# *Farnborough Airport*

## Airspace Consultation Feedback Report **Part B** The Proposed Airspace Design

## Feedback Report Part B

Figure 7 Extent of Farnborough arrivals from 7,000ft compared with original consultation areas

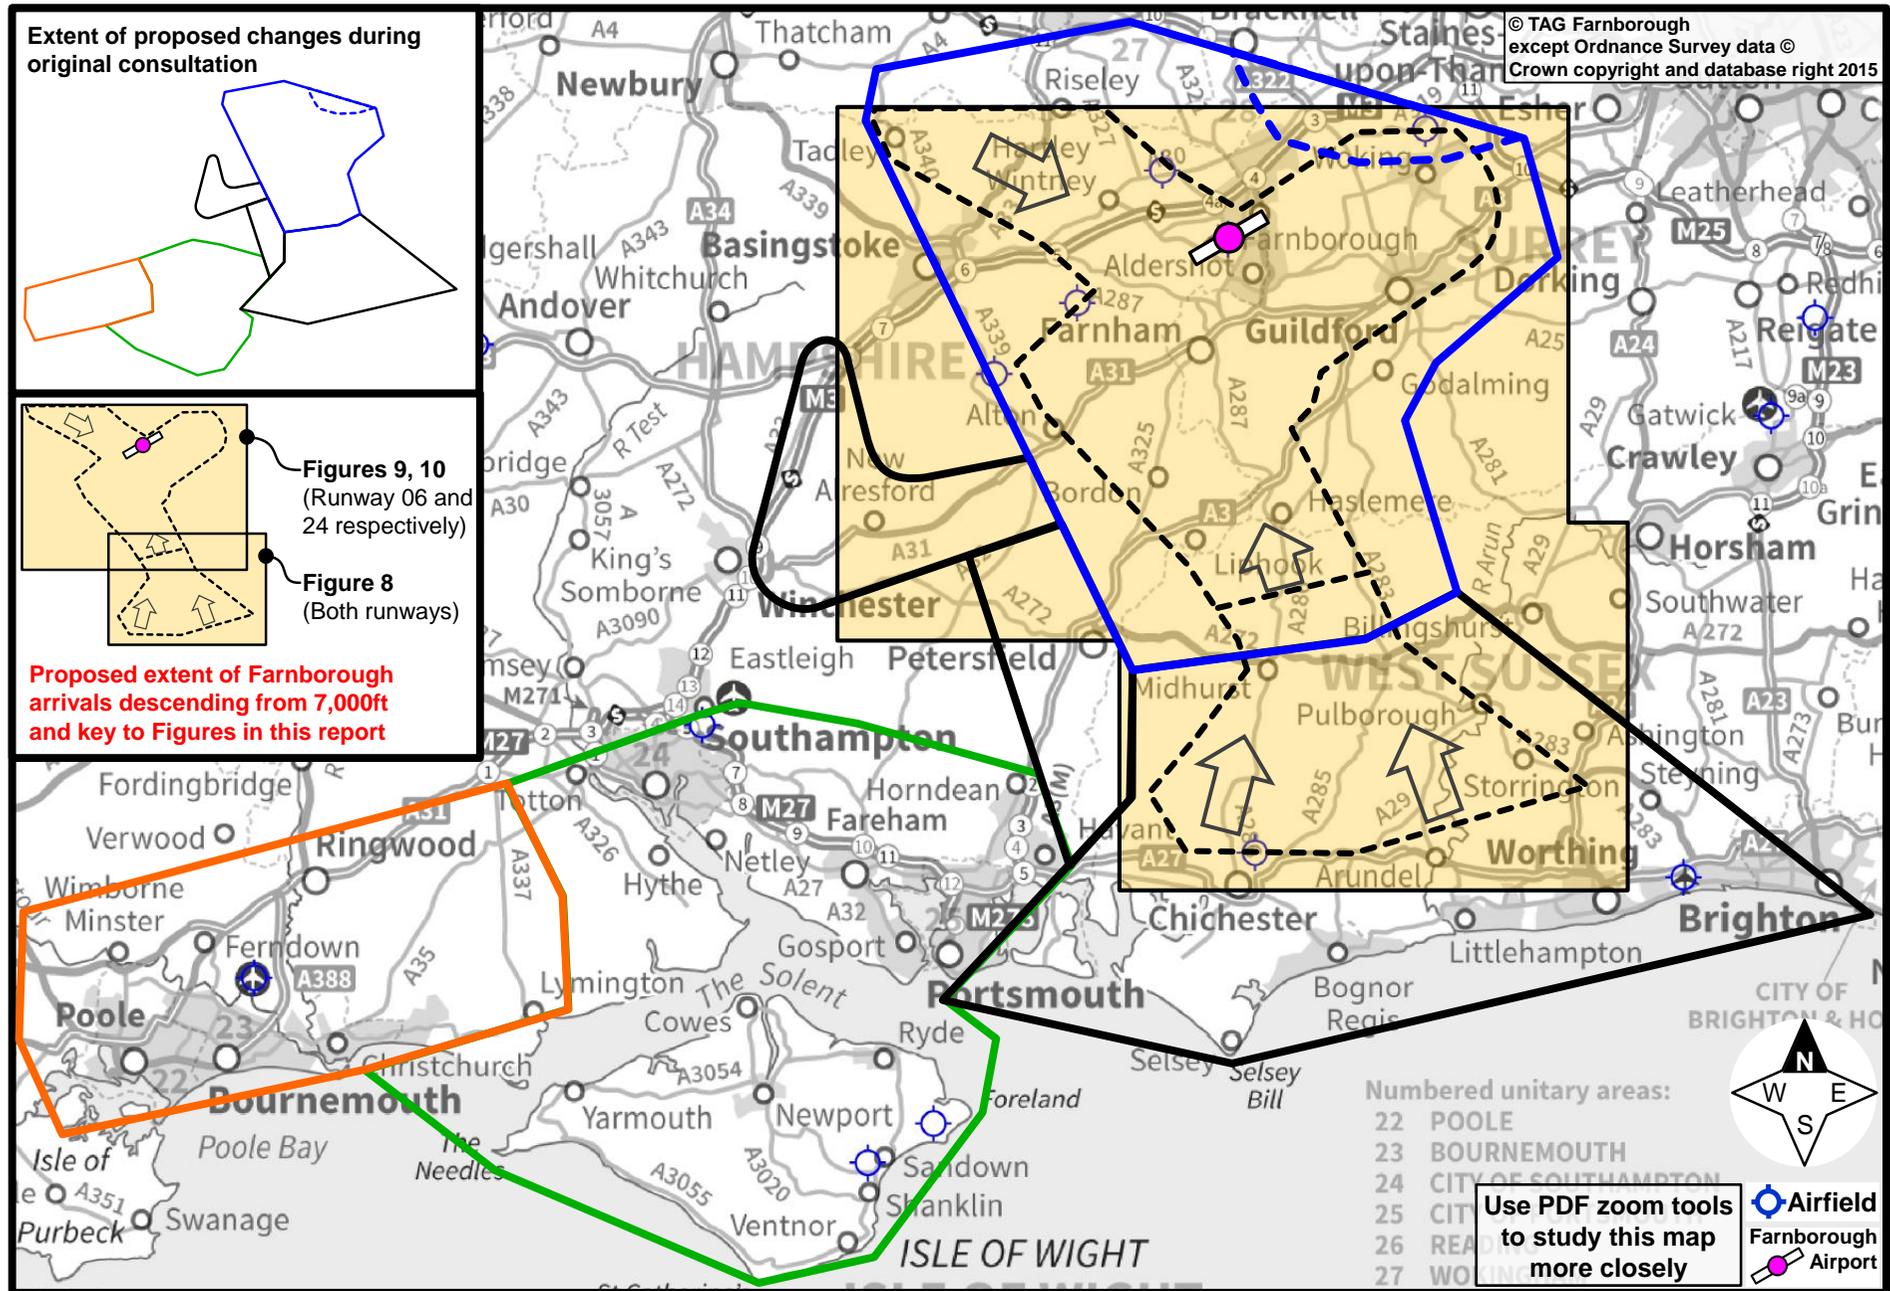
- 4.31. The dashed black lines in Figure 7 below illustrate the extent of the proposed arrival routes post-consultation. These routes are known as Standard Terminal Arrival Routes (STARs). The originally consulted upon wide swathes have been refined into narrower swathes.

**Figure 12 CTR: Consulted Option 25 (L), Post-Consultation Option 34 (R)**

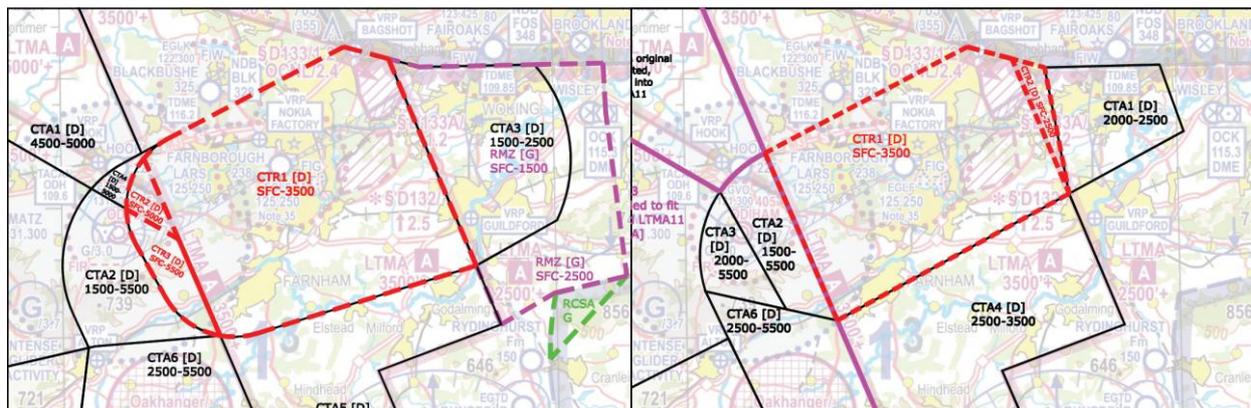
- 5.10. The original small CTR was designed to protect our arrivals and departures, to be compatible with RAF Odiham and to allow for straightforward VFR transits. We were challenged to further reduce the impacts the CTR might have on other airspace users, primarily by suggesting it be made even smaller and the RMZ removed. These points came from consultation feedback, primarily via concerns about funnelling/ compression especially in the 'gap' between Guildford and Gatwick.
- 5.11. The proposed CTR has therefore been further reduced in size, the originally proposed RMZ has been removed and the CTAs to the immediate east and west have also been reduced in size and their bases raised by at least 500ft.
- 5.12. These modifications are still predicated on the regular provision of VFR transits. It would allow for a near-replication of current-day GA traffic patterns.

- 5.13. The reduction in overall width and length has been made possible by introducing a small sliver of CTR to the east (right hand illustration, CTR2) and by reducing the CTA/RMZ requirement in that area. Option 34's CTR2 is designed to reduce TCAS alerts between Farnborough aircraft on final approach to Runway 24 and aircraft operating beneath the revised CTA1 south of Fairoaks, the primary GA departure route from that airfield. We contend that the addition of CTR2 is far outweighed by the removal of significant volumes from the CTR/CTAs in the vicinity.

Figure 13 Lasham-Odiham area

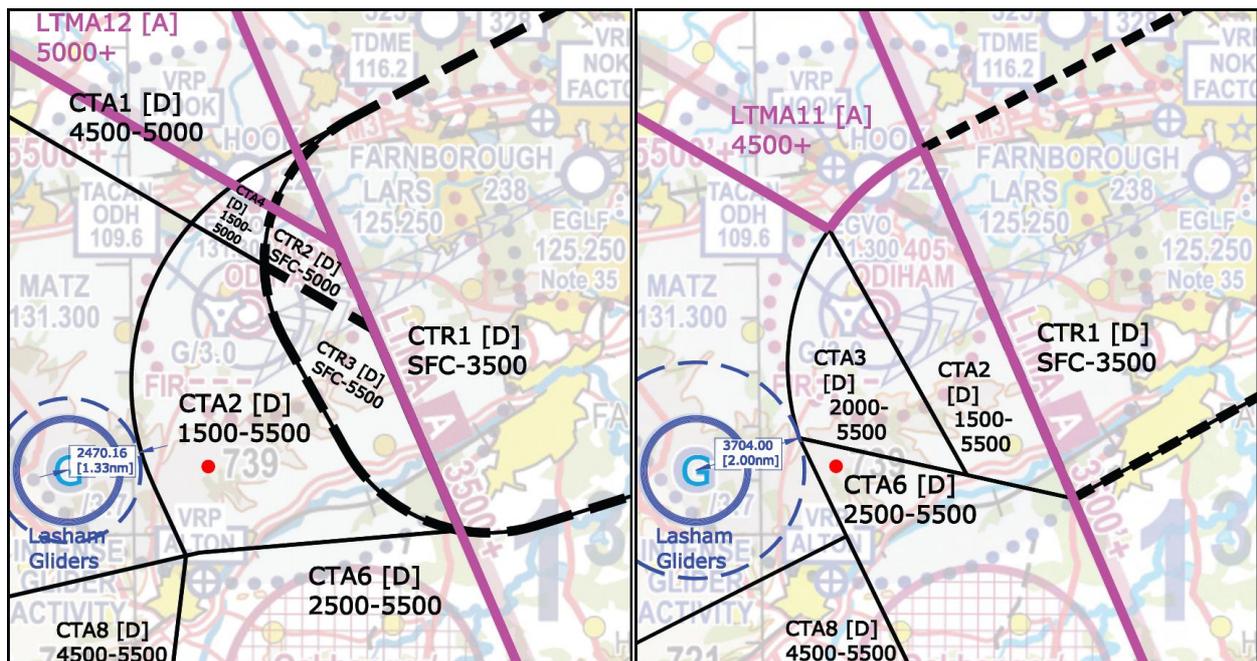
- d. The proposed CTAs between Lasham and Odiham originally extended to 1.3nm from the centre of Lasham's airfield, to 1,500ft (Figure 13 on the left).  
We took their information about circuits from the airfield and used it to revise the CTAs (Figure 13 on the right).  
The closest any proposed airspace is to Lasham's airfield centre is now 2nm at 2,000-2,500ft altitude.  
The spot-height of 739ft (red dot) is not only a useful reference point, but allows for a 1,761ft Class G vertical gap between the high ground and the modified CTA6 airspace base. We believe that this compromise goes some way to mitigating these concerns.

**Figure 14 Western: Consulted Option 25 (L), Post-Consultation Option 34 (R)**

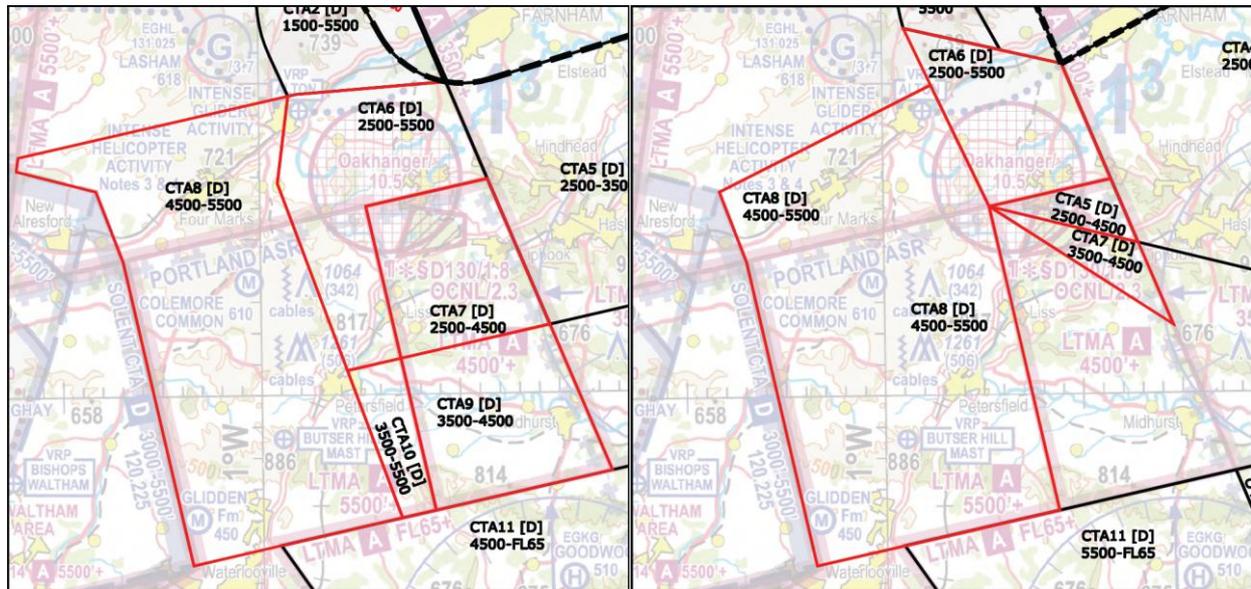
5.25. Airspace volumes impacting the gliding community and similar non-powered/ low powered aircraft have been reduced, their bases raised and their 'corridor' widened, to almost replicate how they currently fly to and from key sites, such as between Lasham and Parham.

5.26. Note how the northern edge of CTA8 has been shifted south, away from Lasham, following consultation feedback.

**Figure 15 Southern: Consulted Option 25 (L), Post-Consultation Option 34 (R)**

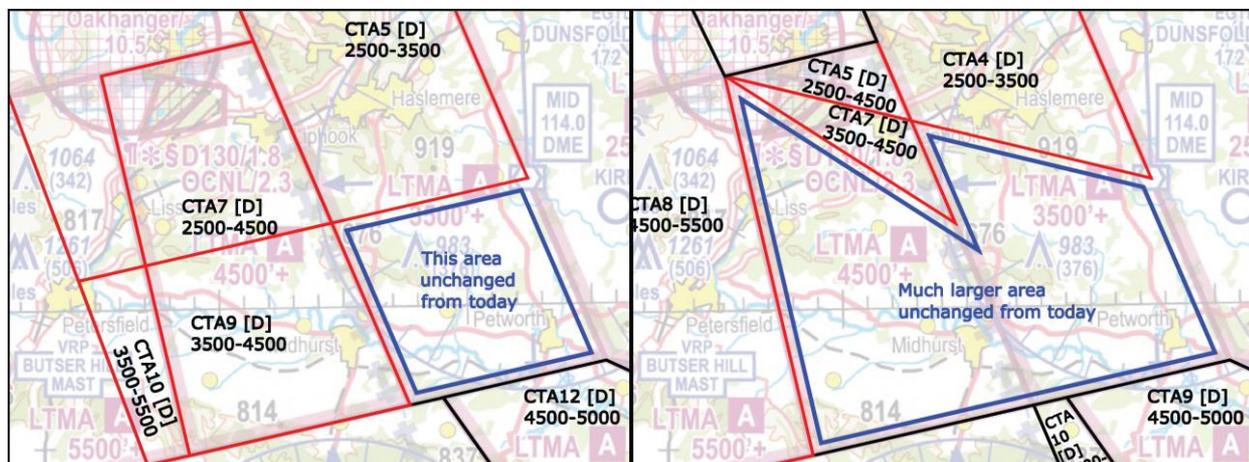
5.27. Note how today's bases (blue) have been retained in a much larger area following consultation feedback.

- 5.28. The modifications to CTAs 4, 5 and 7 on the right hand chart in Figure 15 were made using information and data supplied to us by Southdown Gliding Club (SDGC) for this consultation (see adjacent and below).
- 5.29. Their information allowed us to increase the size of the unchanging areas, meaning the gliding transit 'corridor' could be near-replicated.

**Figure 17 Parham area: Consulted Option 25 (L), Post-Consultation Option 34 (R)**

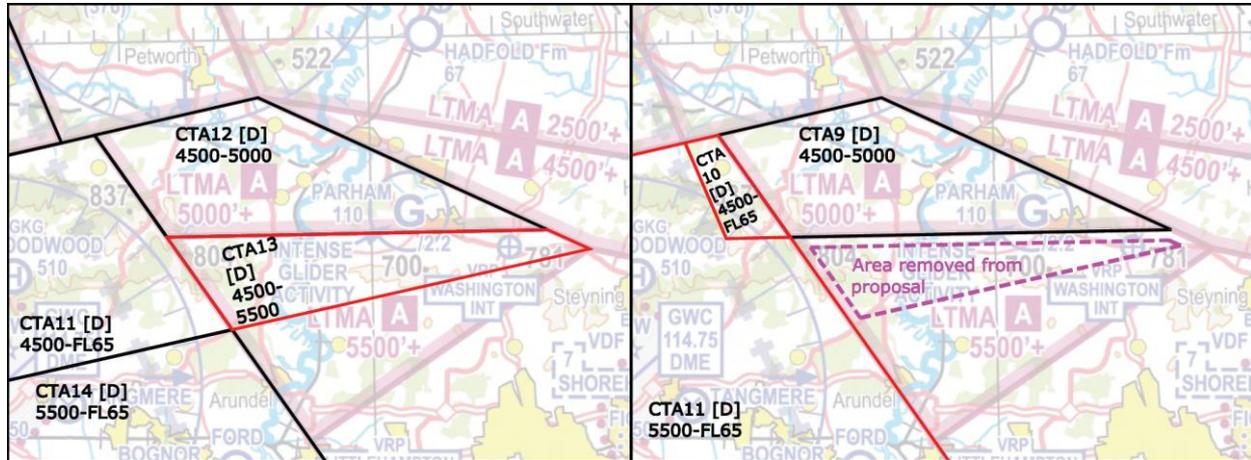
- 5.32. Option 25's CTA13 to the south of Parham was originally intended to allow our arrivals to descend through 6,000ft towards 5,000ft.
- 5.33. Following simulations and expert opinion, it was considered that the area would only occasionally be 'grazed' by arrivals under certain circumstances.
- 5.34. We took the opportunity to reduce the impact on Parham's south side by removing that volume.

- 5.35. The small sliver of Option 34's CTA10 (right hand illustration) is where our proposed arrivals may still descend through 6,000ft towards 5,000ft. This allowed us to raise the proposed base of Option 25's CTA11 (left hand illustration) amalgamating it with Option 25's CTA14, to create a single, higher, wider base. See Option 34 CTA11. This would also reduce the impact on Goodwood aerodrome by reducing the originally-proposed 2,000ft CAS base drop north of that airfield, to a 1,000ft base drop.
- 5.36. The area directly above Parham could not be changed (Option 25's CTA12, Option 34's CTA9). Note that the base is proposed to drop by only 500ft, minimising the impact as much as possible.

**Figure 18 NW area: Consulted Option 25 (L), Post-Consultation Option 34 (R)**

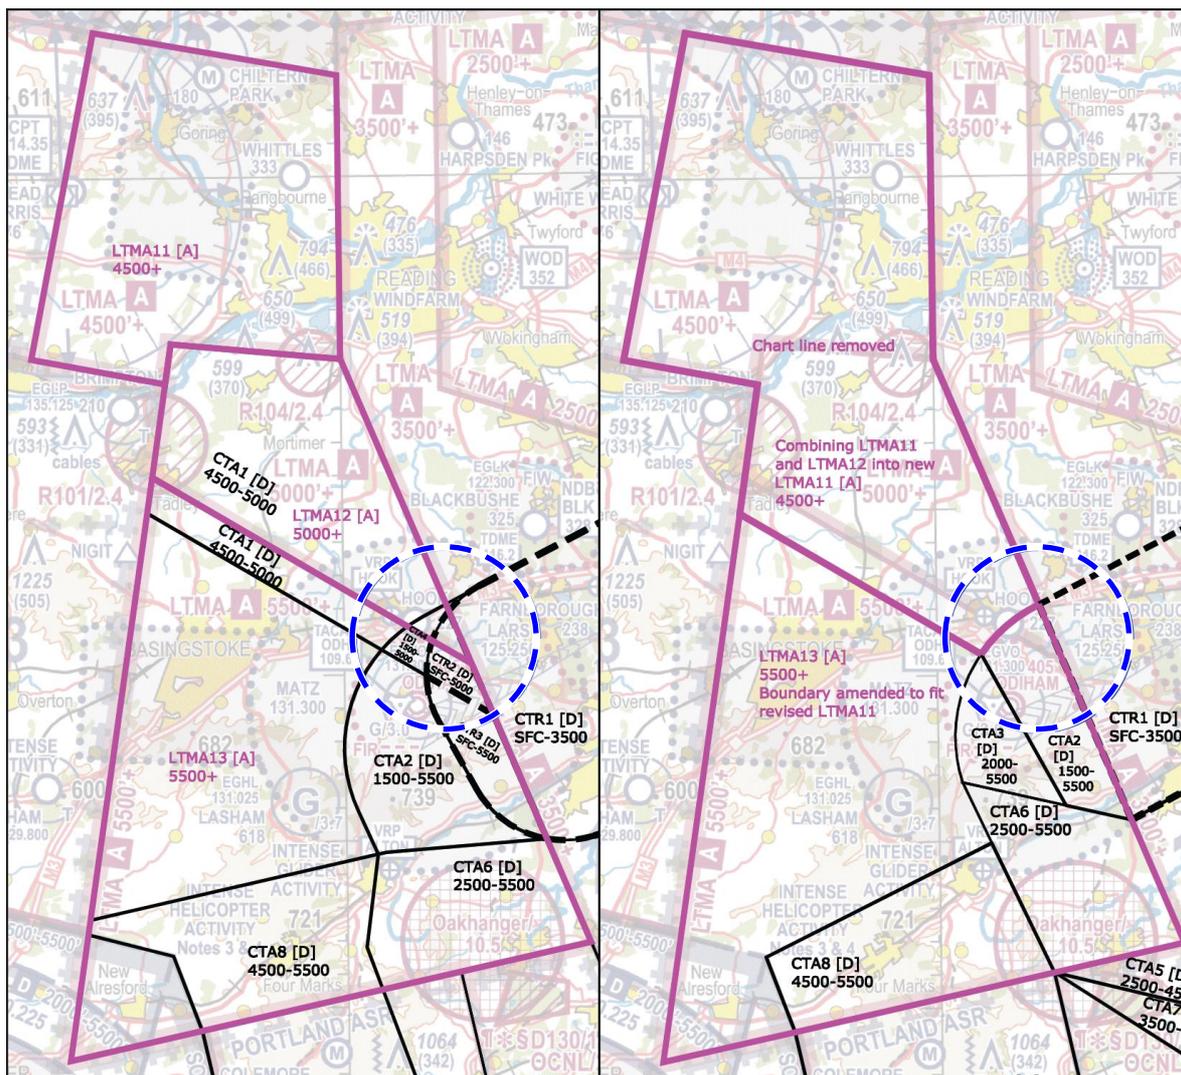
- 5.41. We identified this area as a particularly complex confluence of Class A and Class D boundaries. See the area highlighted by dashed blue circles in Figure 18, comparing left with right:

- 5.42. We originally consulted upon Class D in the area beneath, and adjacent to, LTMA12. The decision was made at the time with the best intentions and knowledge. We believed it would be possible to provide some VFR access (albeit extremely limited due to the proximity of LTMA12).

- 5.46. The consequence of this is that the volume would need to be Class A LTMA with a base of 4,500ft, subsuming the originally-proposed Class D slivers and rationalising the boundaries. This includes combining LTMA12 with LTMA11 at CPT, further reducing the number of CAS charting lines, and revising LTMA13's outline.
- 5.47. We contend that this is the best solution to a complex problem. The intended spirit of Class D is to provide VFR access, which would be impractical in those minute volumes so closely abutting Class A LTMA.
- 5.48. We have therefore not increased the impacts on other airspace users in this vicinity since consultation, and have simplified CAS boundary charting following feedback.

Figure 21 SIDs (light blue Opt 25, dark blue Opt 34)  
 STARs (light orange Opt 25, mostly over-drawn by dark orange Opt 34)

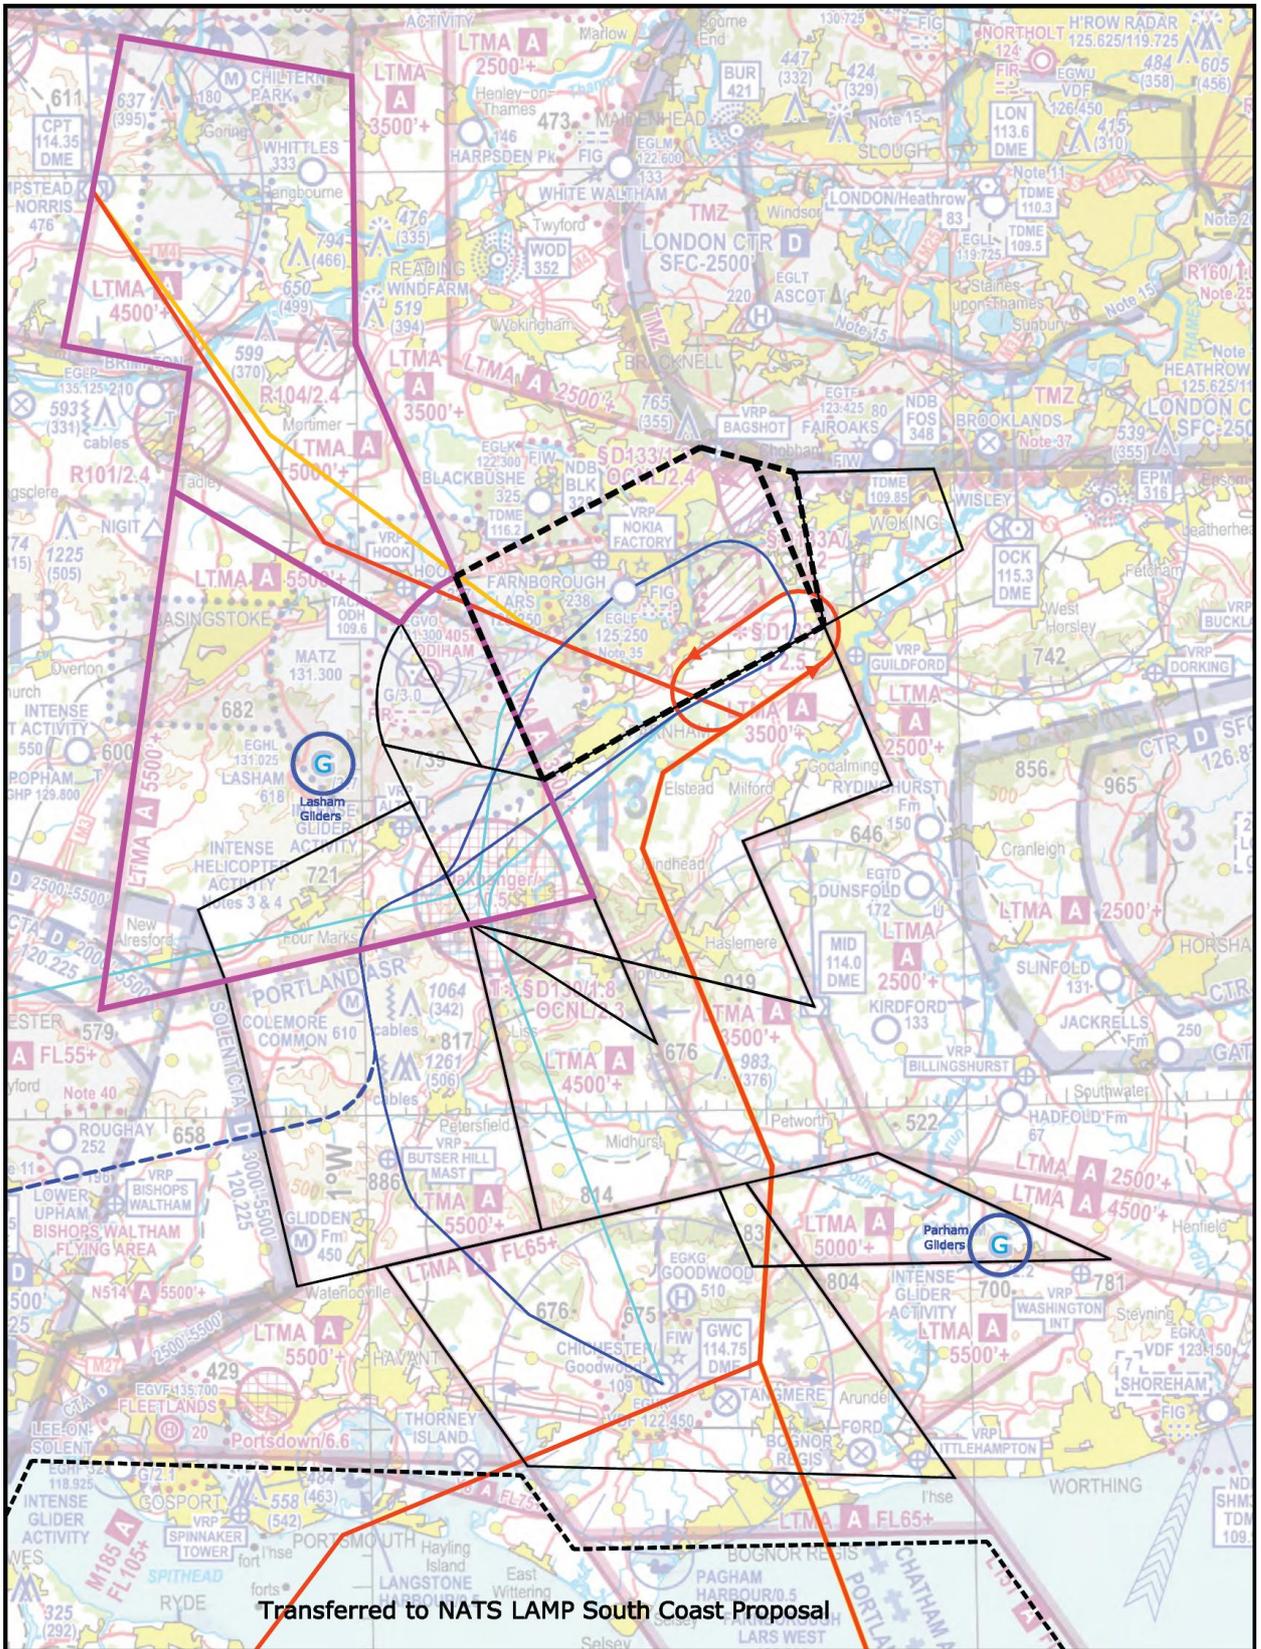
- Figure 21     SIDs (light blue Opt 25, dark blue Opt 34)  
                  STARs (light orange Opt 25, mostly over-drawn by dark orange Opt 34)
- Figure 22     Consultation Airspace (Option 25)
- Figure 23     Post-Consultation Airspace (Option 34)
